SAFETY RECALL

Mack Trucks Inc.
Greensboro, NC USA

Date	Number	Release	Page
06.2024	SC0465	06	1(5)

Steering Draglink AN, GR, TE

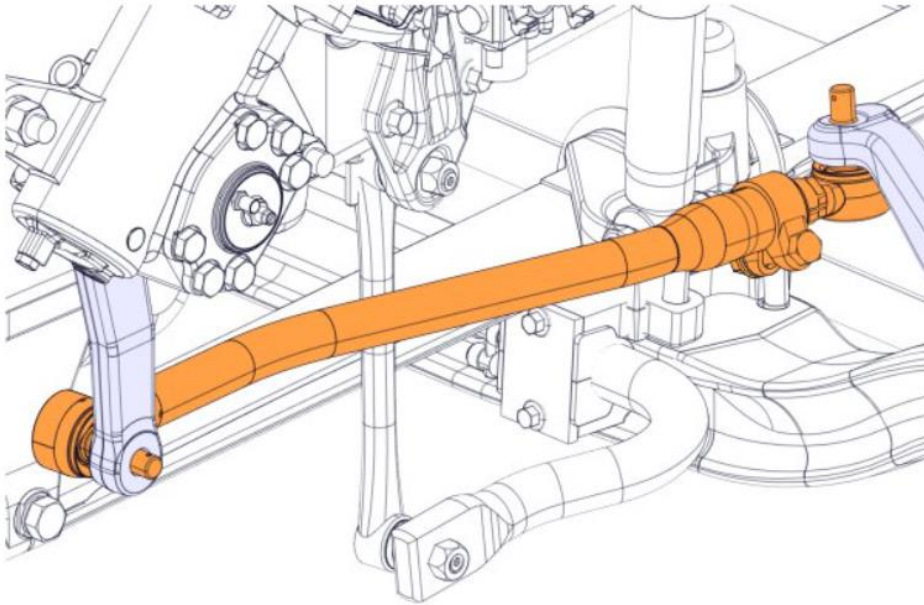
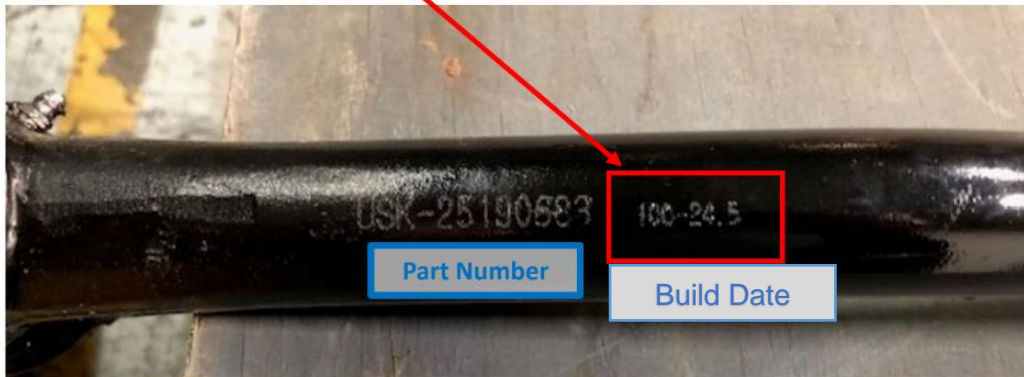
5. Identify the draglink assembly connecting the steering lever and the pitman arm.

NOTE: Some trucks may have dual draglinks depending on configuration.

6. Locate the part number stamped or etched on the draglink.

7. Verify the part number on the draglink to the reference part number in the table below. Confirm whether the part number and build date match or not.
 - a. If the build date matches to the dates on the table, the draglink is NOK and must be replaced with a new one. Proceed to step 8.
 - b. If the build date is not on the table, the draglink is OK and the truck can be returned to service.
